APPENDIX A

FACILITY ASSESSMENT PHOTO REPORTS

CITY HALL

1.0 Site Assessment

Comment #: CH-03

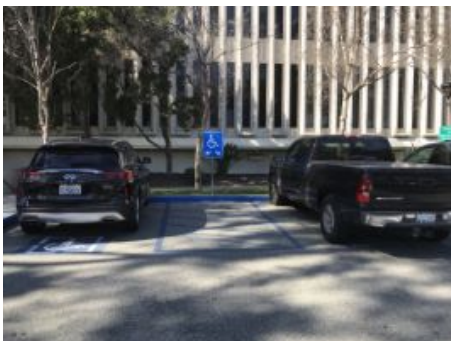
Signs identifying van parking spaces shall contain additional language or an additional sign with the designation "van accessible".

Comment #: CH-08

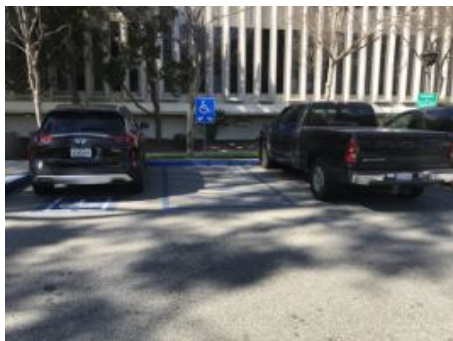
Deficiency: Parking - Accessible Route - Adjacent

Accessible parking spaces are not dispersed when serving multiple accessible entrances.

Revise parking layout. Where parking serves more than one accessible entrance, accessible parking spaces shall be dispersed and located on the shortest accessible route to the accessible entrances.

Comment #: CH-23

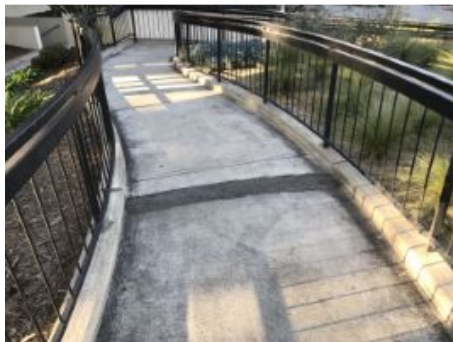
Deficiency: Ramps - Vertical Change - General

The accessible route has areas of vertical level changes on ramp run. 1" high level change measured along the top portion of the ramp.

Comment #: CH-34

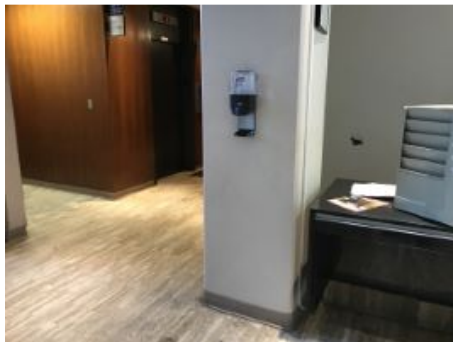
Deficiency: Accessible Route - Reach Ranges - Side Reach

Element for side reach is not located within 15-inches minimum to 48-inches maximum AFF (to to a 10-inch depth). 51" AFF measured to the antibacterial dispenser control.

Adjust height of element to provide a maximum reach range of 48 inches (1219 mm) maximum and the low side reach shall be 15 inches (381 mm) minimum above the finish floor or ground.

Comment #: PD-18

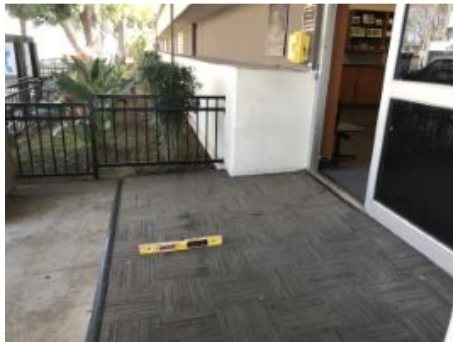
Deficiency: Accessible Route - Slopes - Cross Slope

The cross slope of accessible routes exceeds 1:48 (2.0 %). 4.2% to 4.9% cross slope measured along the route. Route is 7' long.

Comment #: PD-39

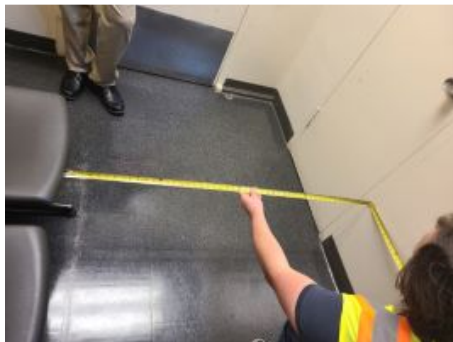
Deficiency: Interior Doors/Doorways/Gates - Clearances: Front - Pull Side Approach

60 inches of maneuvering space beyond the pull side of the door is not provided.

Comment #: PD-52

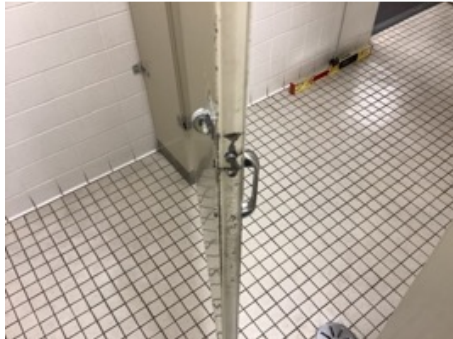
Deficiency: Accessible Toilet Stall - Door Hardware - Handle Both Sides

There is no pull handle on the interior side of the stall door.

Comment #: PD-62

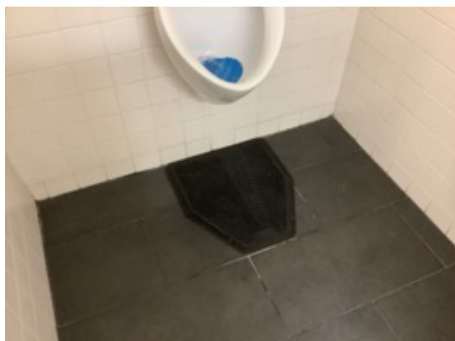
Deficiency: Restroom Access - Floor Surface - Mat

Carpet or carpet tile is not securely attached.

Comment #: LIB-16

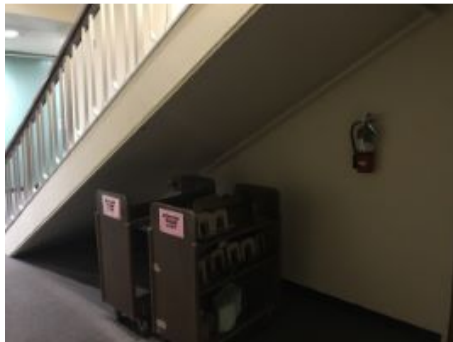
Deficiency: Accessible Route - Vertical Clearance - Height

Fire extinguisher is located in an area where vertical clearance is less than 80-inches minimum.

Comment #: LIB-24

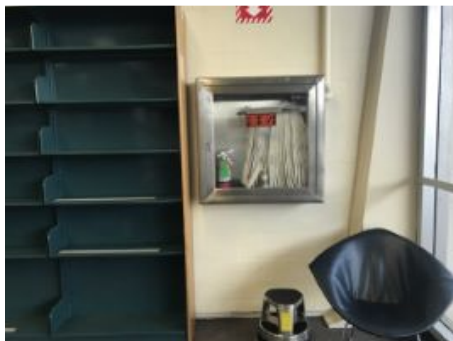
Deficiency: Accessible Route - Reach Ranges - Side Reach

Element for side reach is not located within 15-inches minimum to 48-inches maximum AFF (to to a 10-inch depth). 53" to 58" AFF measured to the fire extinguisher and fire hose cabinet controls.

Comment #: PALO-030

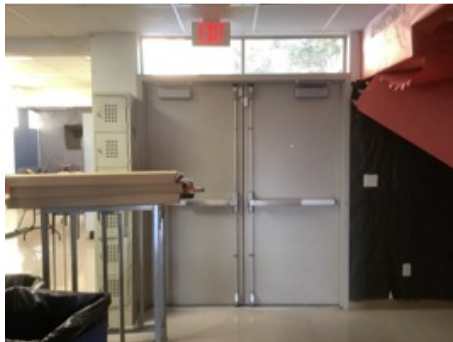
Deficiency: Exterior Doors/Doorways/Gates - Tactile Sign - General

No permanent tactile exit sign has been provided.

Comment #: PALO-036

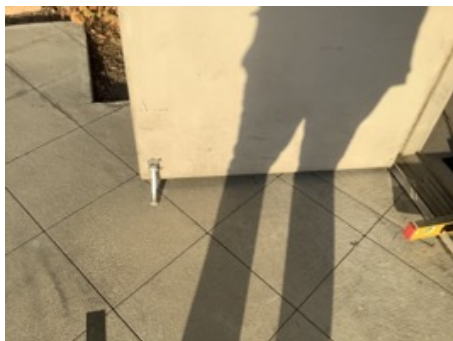
Deficiency: Exterior Doors/Doorways/Gates - Hardware - Smooth Surface

Lower 10 inches of door is not smooth.

Comment #: PALO-0118

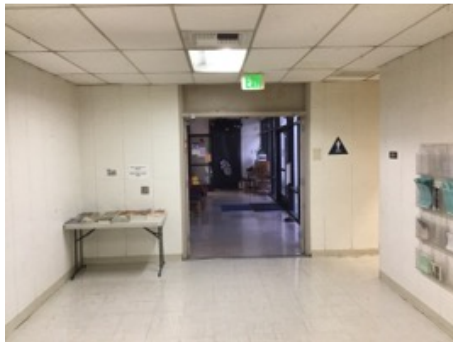
Deficiency: Interior Doors/Doorways/Gates - Tactile Sign - General

No permanent tactile exit sign has been provided.

Comment #: PALO-0161

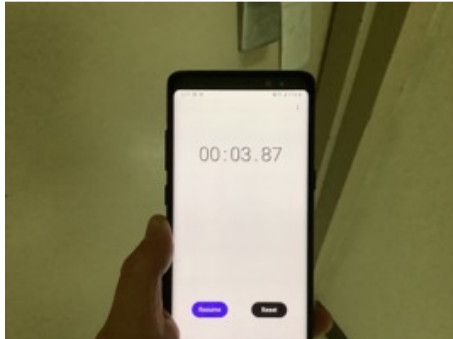
Deficiency: Restroom Doors - Operation - Closing Speed

The door closes faster than the minimum 5 seconds.

Comment #: PALO-0232

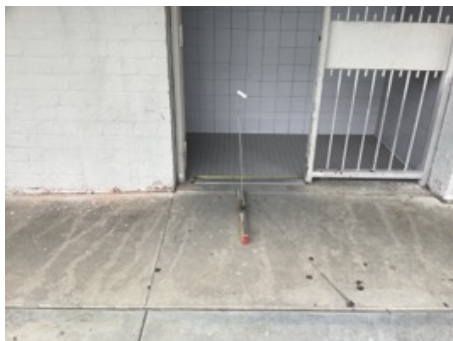
Deficiency: Restroom Doors - Landing - Slopes

The slopes at the door landings exceed the allowable 2.0% grade.

Comment #: GAN-0214

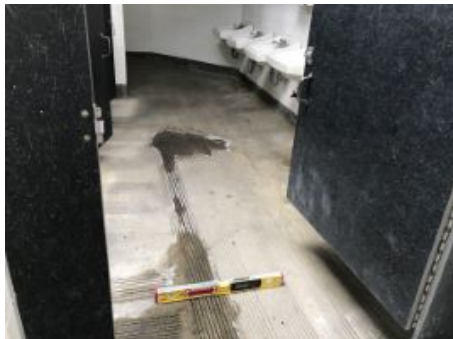
Deficiency: Restroom Interior Space - Floor Surface - Slopes

The floor surface has slopes that exceeds the allowable 1:48 (2%) grade in any direction. 2.4% to 7.2% cross slope measured along the floor surface in front of the lavatories.

Comment #: GAN-0215

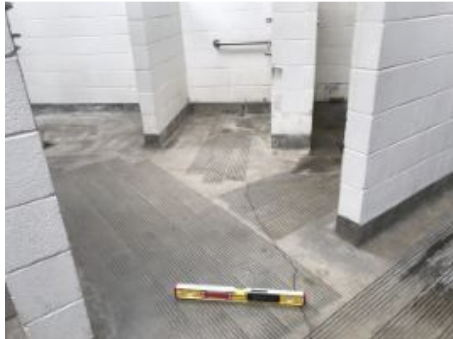
Deficiency: Restroom Interior Space - Floor Surface - Slopes

The floor surface has slopes that exceeds the allowable 1:48 (2%) grade in any direction. 3.0% to 4.2% cross slope measured along the route to the showers.

Comment #: PHIL-35

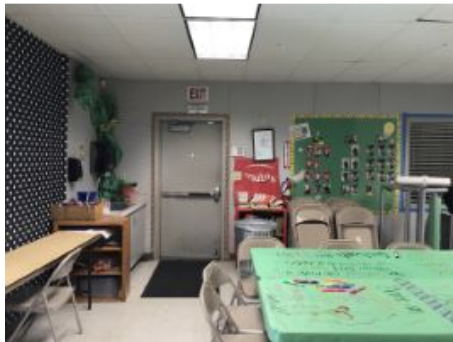
Deficiency: Interior Doors/Doorways/Gates - Hardware - Smooth Surface

Lower 10 inches of door is not smooth. Door stop installed at bottom of door.

Comment #: PHIL-57

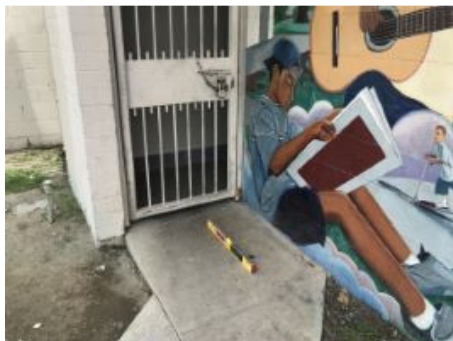
Deficiency: Restroom Doors - Clearances: Front - Latch Clearance

24-inches (exterior) not provided at latch side clearances.

Comment #: JFK-046

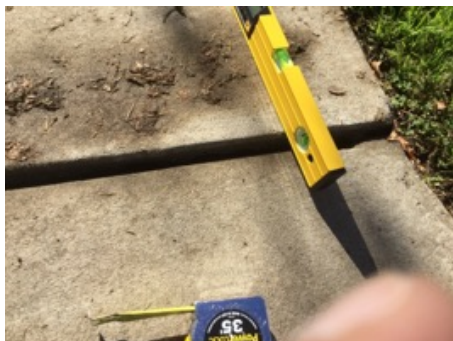
Deficiency: Accessible Route - Vertical Displacement - Bevelment Slope

Accessible route has multiple locations where changes in level over 1/4" vertical or 1/2" beveled occur.

Comment #: JFK-066

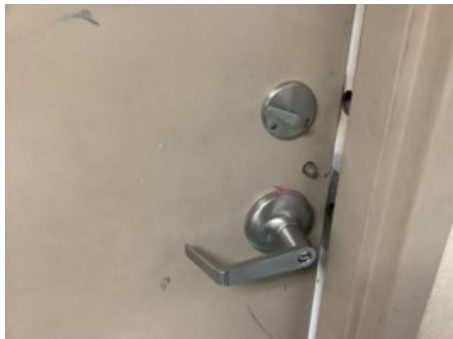
Deficiency: Exterior Doors/Doorways/Gates - Hardware - Operation

The operable part requires tight grasping, pinching and/or twisting of the wrist to operate.

Comment #: JFK-085

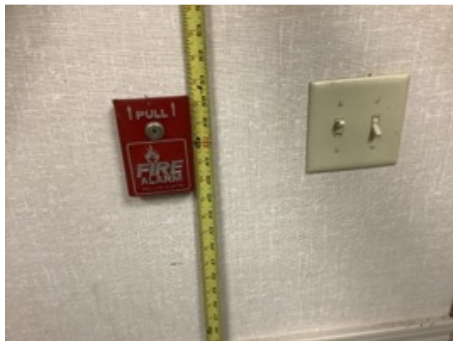
Deficiency: Manual Fire Alarm Box - Reach Ranges - Side Reach

Fire alarm exceed 48-inches maximum AFF in the process of having to lift the handle. This also requires more than one motion to set off fire alarm.

Comment #: JFK-0140

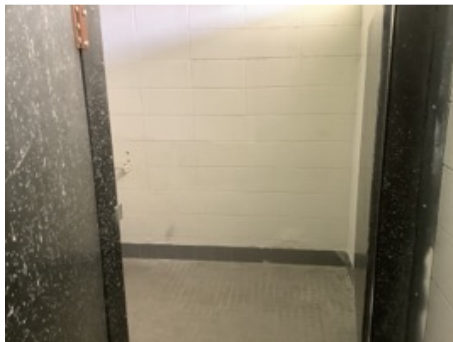
Deficiency: Accessible Toilet Stall - Door - Self-Closing Door

The stall door is not self closing.

Comment #: JFK-0153

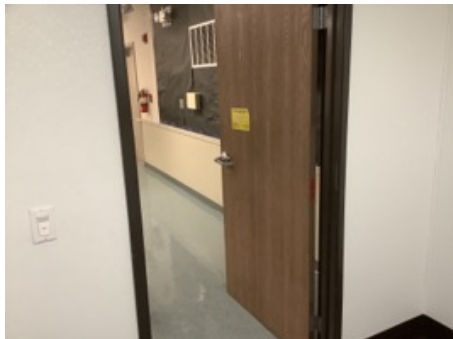
Deficiency: Accessible Toilet Stall - Door - Self-Closing Door

The stall door is not self closing.
